VOLLMER ROAD RV AND BOAT STORAGE
8815 VOLLMER ROAD
COLORADO SPRINGS, CO 80908

PROJECT NAME: Landscape Plan
 PROJECT ADDRESS: 8815 VOLLMER ROAD, COLORADO SPRINGS, CO 80908
 PROJECT DESCRIPTION: SITE PLAN

SHEET TITLE:
LANDSCAPE PLAN

Landscape Plan Drawings_V1.pdf Markup Summary

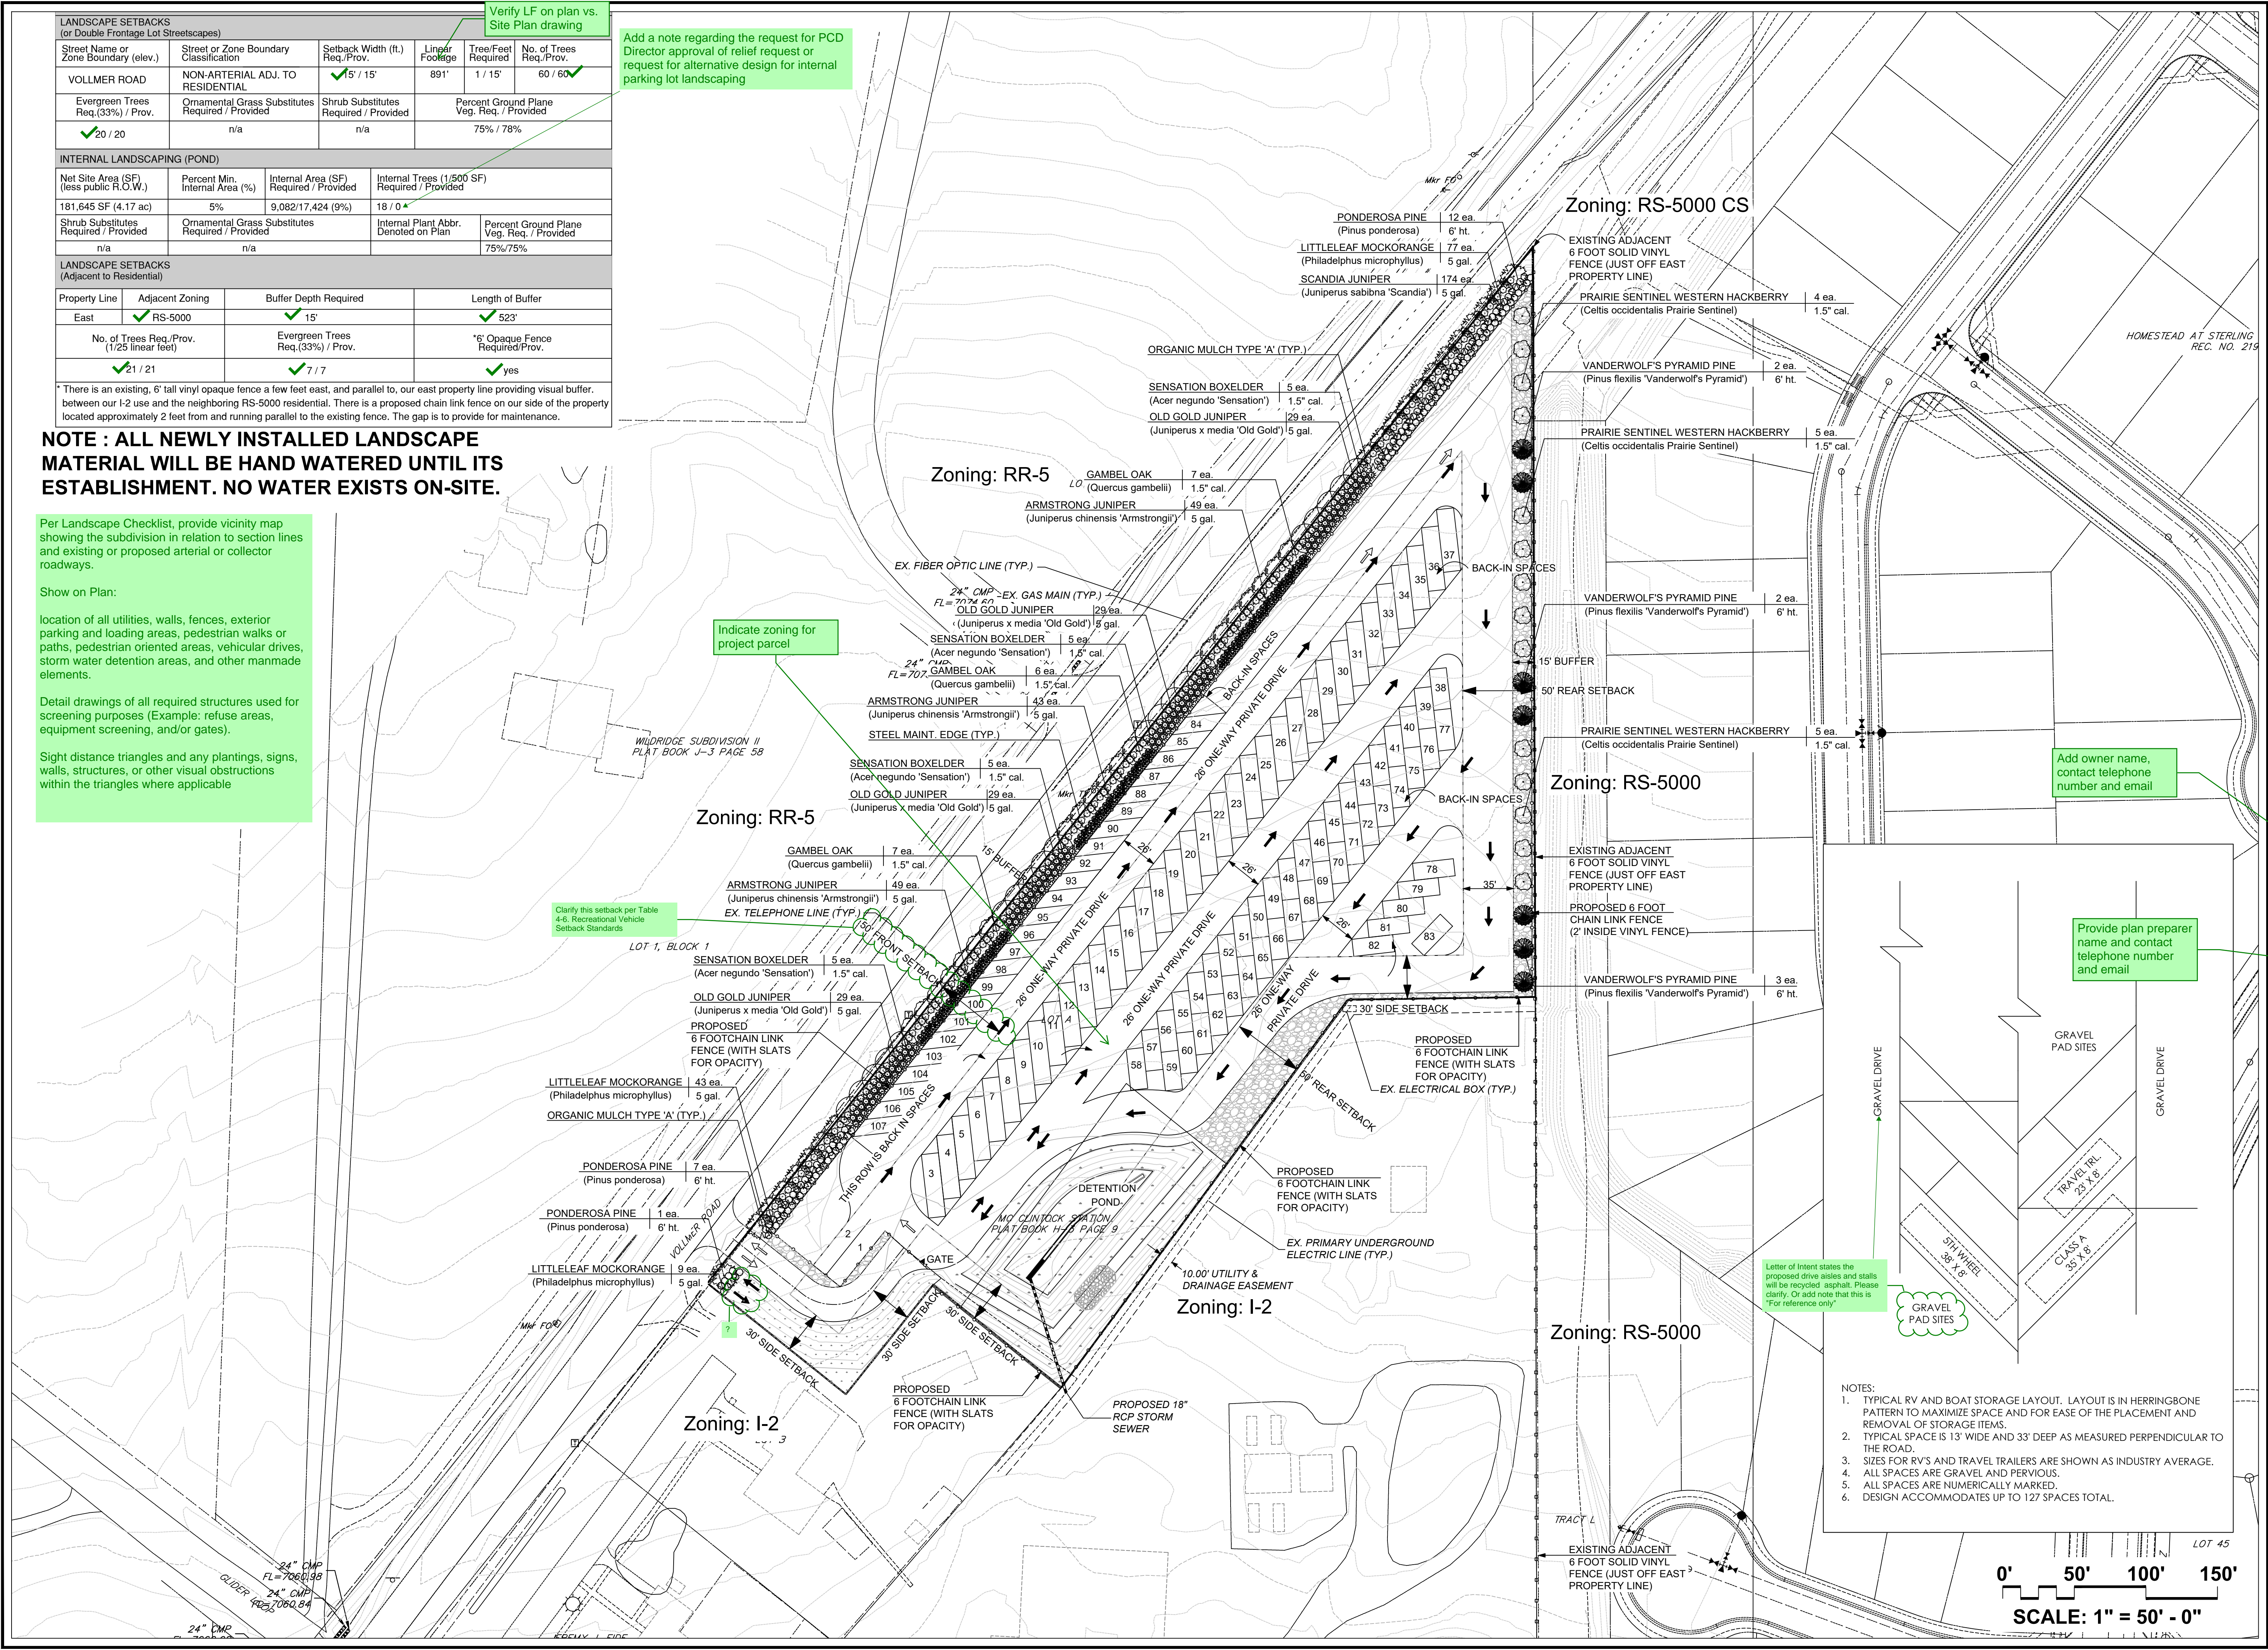
Verify LF on plan vs. Site Plan drawing

Add a note regarding the request for PCDDirector approval of relief request or request for alternative design for internal parking lot landscaping

Per Landscape Checklist, provide vicinity map showing the subdivision in relation to section lines and existing or proposed arterial or collector roadways.

Show on Plan:
location of all utilities, walls, fences, exterior parking and loading areas, pedestrian walks or paths, pedestrian oriented areas, vehicular drives, storm water detention areas, and other manmade elements.

Detail drawings of all required structures used for screening purposes (Example: refuse areas, equipment screening, and/or gates).

Sight distance triangles and any plantings, signs, walls, structures, or other visual obstructions within the triangles where applicable

Indicate zoning for project parcel

Clarify this setback per Table 4.5. Recreational Vehicle Setback Standards

Add owner name, contact telephone number and email

Provide plan preparer name and contact telephone number and email

Letter of Intent states the proposed drive aisles and stalls will be recycled asphalt. Please clarify. Or add note that this is "For reference only"
